# NRC Staff Review of NEI/EPRI Reports On Creep And Fracture Toughness Of Zircaloy SNF Cladding

**NRC/NEI Meeting**

**April 18, 2001**

# **NRC Staff Review of NEI/EPRI Report On Fracture Toughness Data For Zirconium Alloys – Application To Spent Fuel Cladding In Dry Storage**

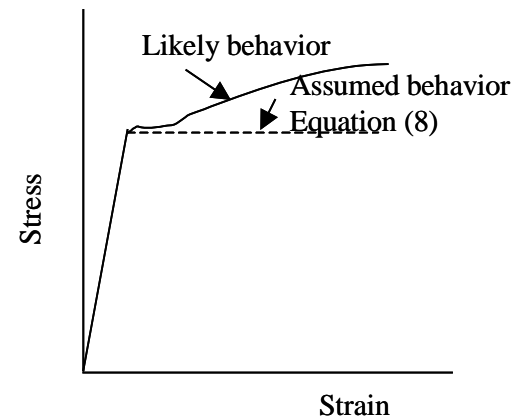
1. In the equation defining  $K_{Ic}$ , the definition of  $\rho$  is not clear. What is the 'position' of the crack? Is it crack size? Is it plastic zone size? Is it crack size plus the plastic zone size?
2. In equation (8), why is the stored elastic energy subtracted from the total strain energy, considering that the strain energy consists of energy for yielding, energy for crack nucleation, and energy for crack propagation?
3. Why is the yield stress being multiplied by the total energy contribution? For example, typically, stress does not remain constant with strain after yielding.

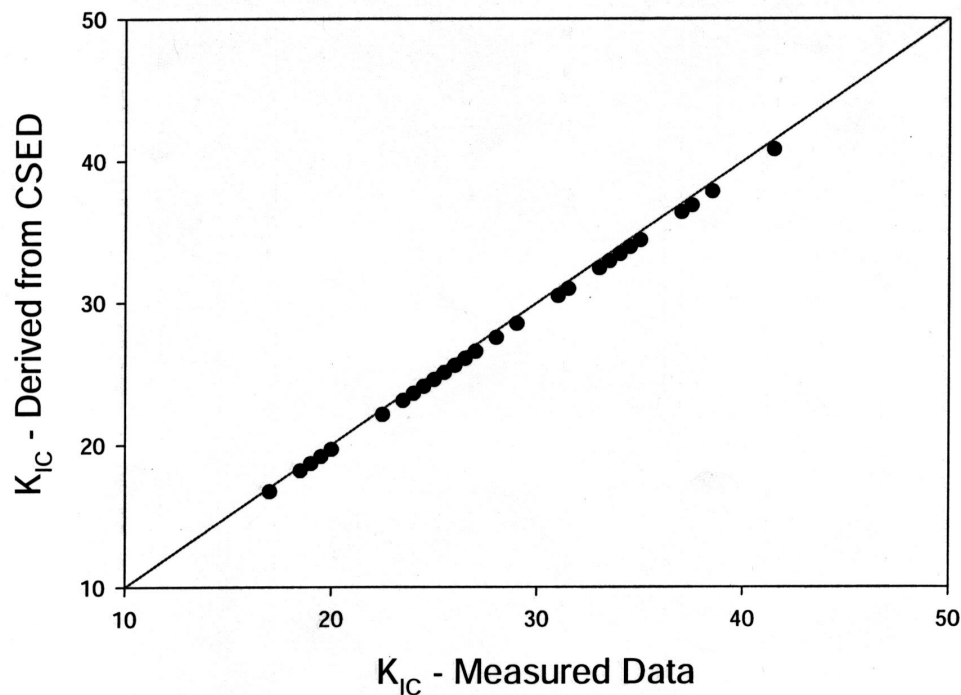
- 7. The total strain energy,  $U_c$ , in equation (13) should be divided by crack length (or, crack area?); otherwise, an imbalance in units exists. However, questions still persist with respect to the adjustable constant, 3.5, which depends on the factor 'r' and its interpretation.**
- 8. CSED approach estimates the fracture toughness of a material on the basis of uniaxial stress-strain curves. Crack initiation and crack propagation under other loading situations, for example creep, might involve complex fracture mechanisms, thus rendering the application of CSED less meaningful.**

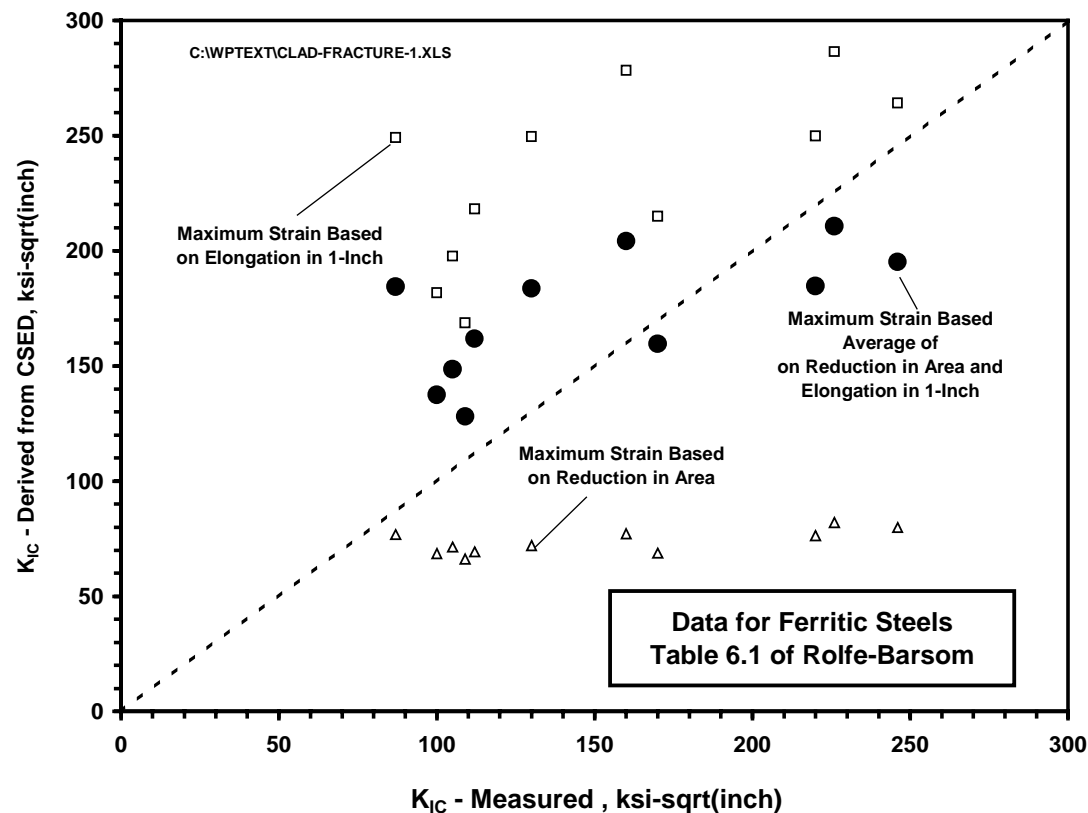
10. When CSED approach was applied to ferritic steels, predicted and measured toughness values differed by a factor of 2.

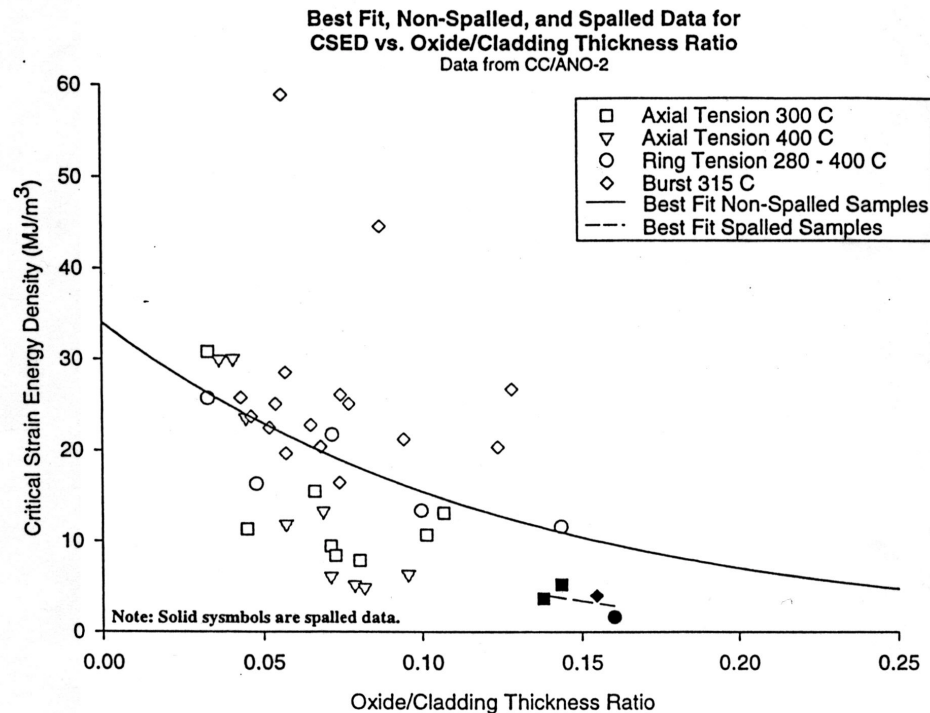
- 11. An examination of Figure 3 of EPRI report, which shows the relationship between CSED and oxide thickness for irradiated and hydrided fuel cladding shows wide scatter in the data.**

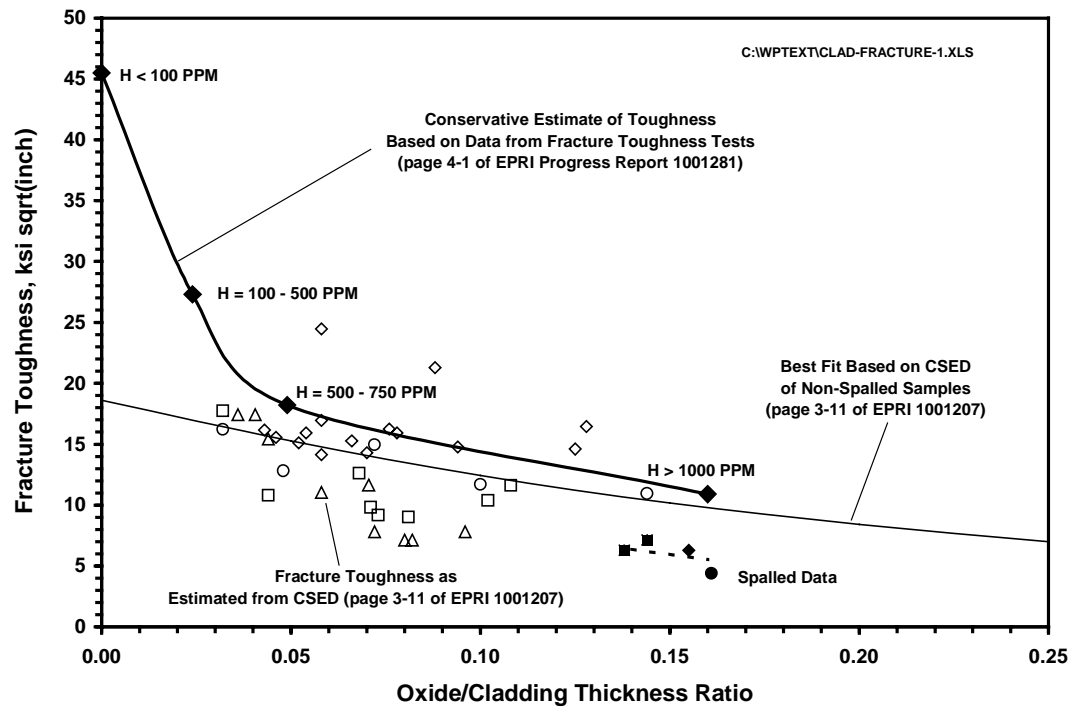
**12. Re-casting the data provides some useful information, although large uncertainties still pertain. In general, CSED estimates seem more conservative.**
